Your reference: SSD 9210 Our reference:

D18/7982

10 December 2018

State Significant Development Application - 2320 & 2321//1223137 - 17-19 Kosovich Place Cecil Park

Figure 4 Vegetation management areas

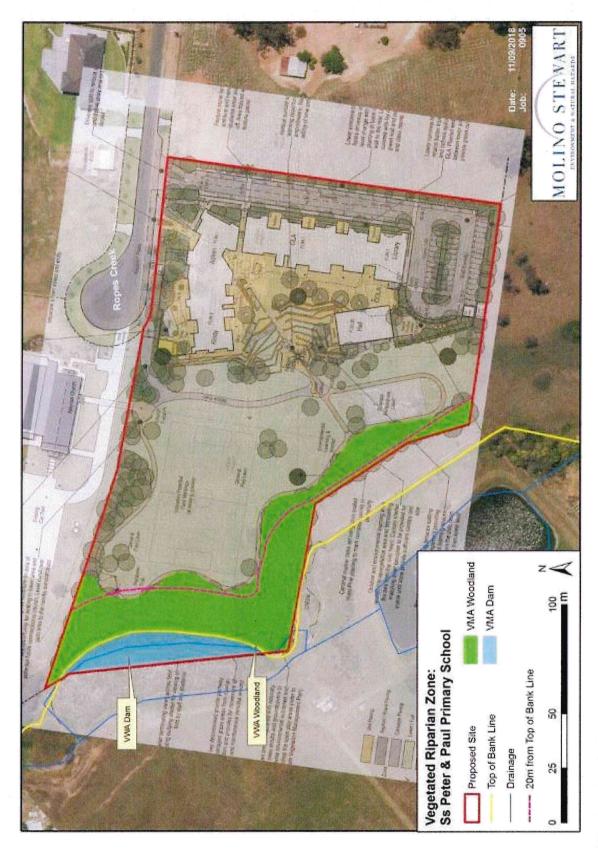
1. At the commencement of building works and in perpetuity the entire property except for the area covered by the vegetation management plan shall be managed as an inner protection area (IPA) as outlined within section 4.1.3 and Appendix 5 of Planning for Bush Fire Protection 2006 and the NSW RFS document Standards for asset protection zones.
